**SERIES 100 - PRELIMINARY
COMPARISON TO ORIGINAL DESIGN
GENERAL ARRANGEMENT**

Drawing Number: **50679-BUR-XX-XX-DR-Z-0001**

Revision: P2.0 - REVERTED TO APPROVED RLB

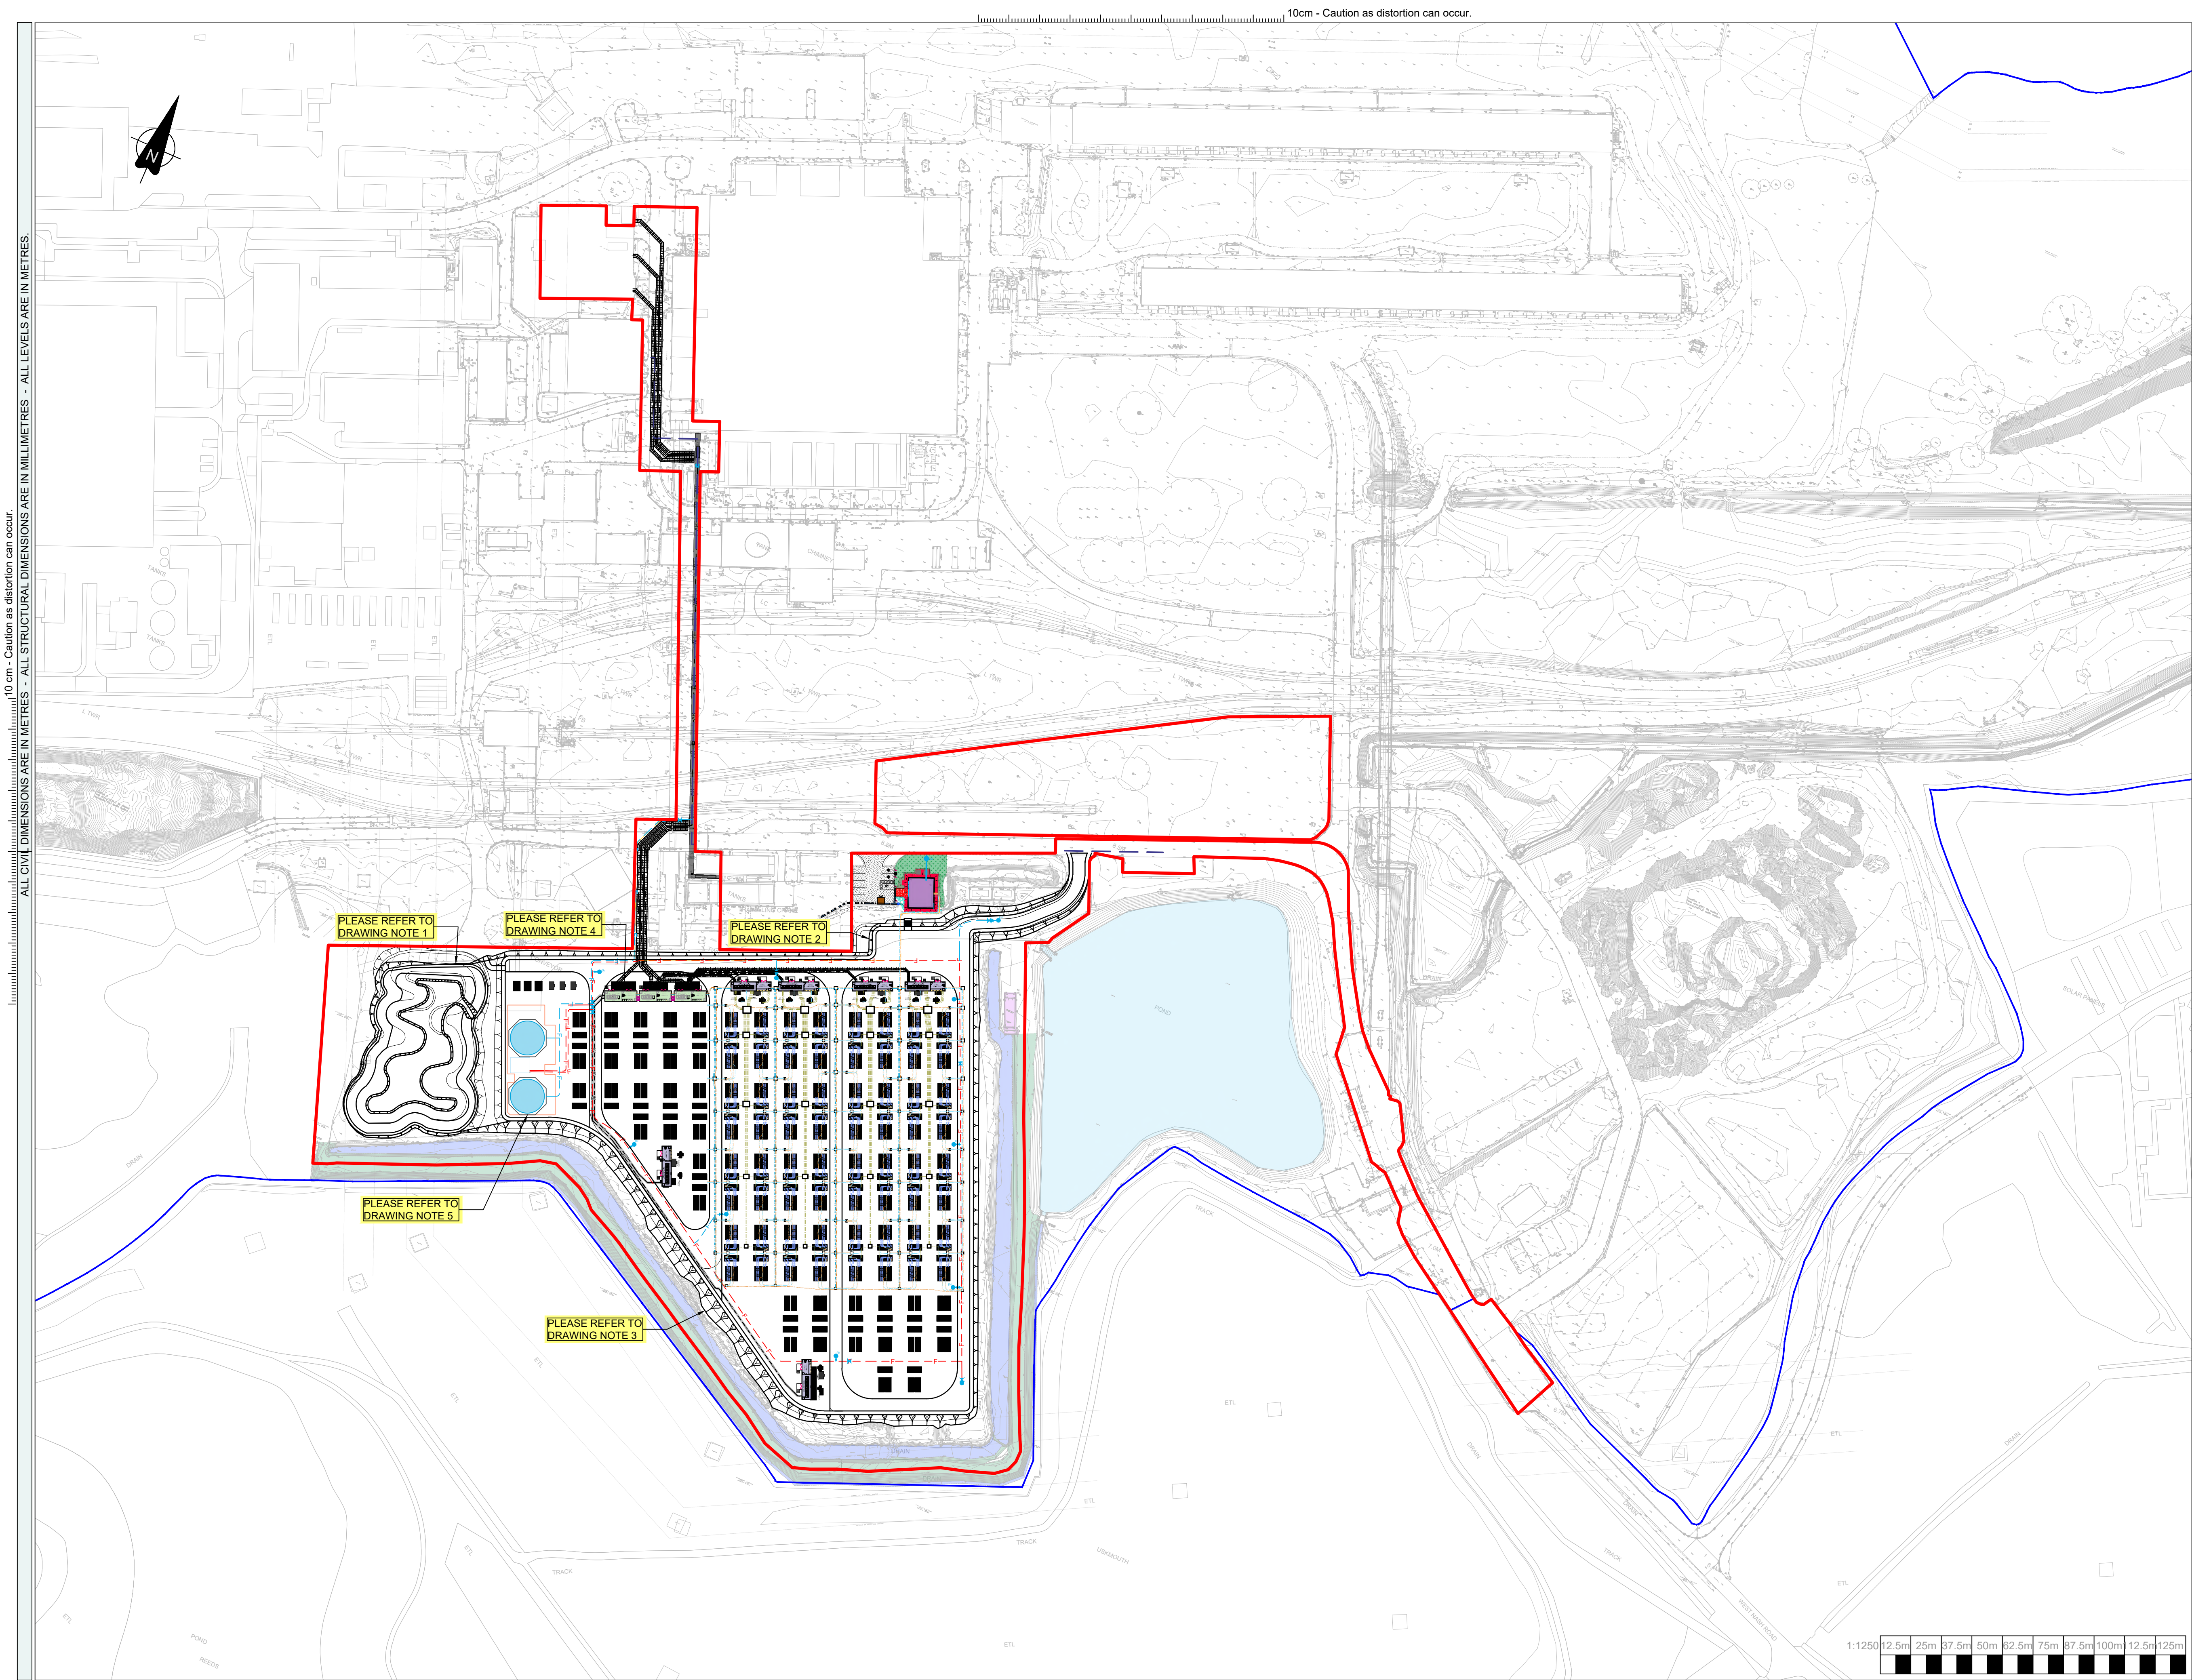
- DRAWING NOTES:**
1. POND DESIGN HAS BEEN AMENDED TO BE LOCATED OUTSIDE OF ELECTRICAL PYLON EXCLUSION ZONE, WHILST MAINTAINING REQUIRED ATTENUATION VOLUMES.
 2. PROPOSED BESS PLATEAU EARTHWORKS ADJUSTED TO BE LOCATED AWAY FROM EXISTING COAL HOPPER CHUTE, AND THEREFORE LIMIT ANY IMPACT ON STRUCTURE.
 3. PROPOSED BESS PLATEAU EARTHWORKS ADJUSTED TO REMOVE REQUIREMENTS FOR GEOTEXTILE REINFORCEMENT. EARTHWORK SLOPES SLACKENED TO REDUCE THE REINFORCEMENT REQUIRED.
 4. SUBSTATION BUILDING POSITIONS ADJUSTED TO AVOID CLASHING WITH OTHER PROPOSED INFRASTRUCTURE, AND ENSURE DESIGNS ARE COORDINATED.
 5. PROPOSED FIRE WATER TANKS HAVE BEEN ADDED TO THE DESIGNS. FIRE WATER TANKS ARE REQUIRED, AS TANKS WITHIN THE EXISTING FIRE BUILDING ARE NO LONGER BEING UTILISED FOR THE PROJECT.
